Far North Solar Farm Limited

Re: Response to Request for Information 5 – The Point Solar Farm Application under the Fast-track Approvals Act 2024 (File ref: FTAA-2509-1100)

Response to RFI 5: (3) Ecology Matters

(i) Fence specifications

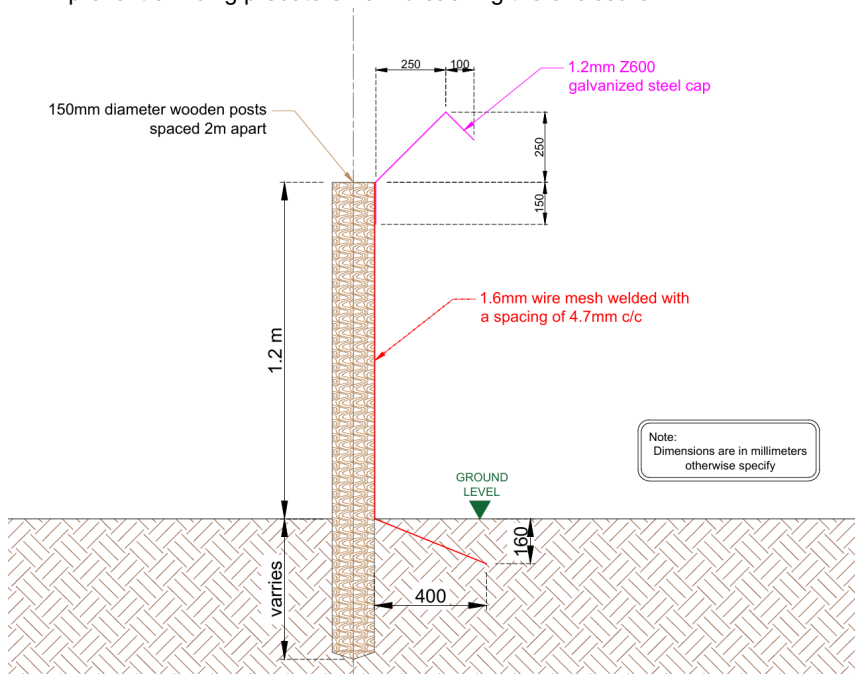
- i) fence specifications;**
- ii) pest exclusion methodology;**
- iii) monitoring and maintenance procedures;**
- iv) Surveillance and incursion response to ensure the area remains free of mice;**
- v) Time differential between pest-free status in the fence and invertebrate or lizard salvage and relocation operations; and**
- vi) Confirmation that Xcluder Fence, the fence contractor stated in the application, is still building.**

FNSF Response: FNSF confirms that the proposed pest exclusion reserve and associated fencing remain part of the ecological enhancement framework for The Point Solar Farm. The detailed design and operational specifications will be finalised through the relevant ecological management plans prior to implementation, with input from the relevant ecological and fencing specialists.

The proposed fence is intended to be a predator-resistant exclusion fence designed to reduce ingress by rabbits, mustelids, hedgehogs, cats, and where practicable, mice. While the original application referenced the Xcluder fence system, FNSF has since been in discussions with experienced local fence contractors familiar with predator reserve fencing systems and equivalent designs are available within New Zealand. FNSF has received a fencing proposal that includes using Xcluder components.
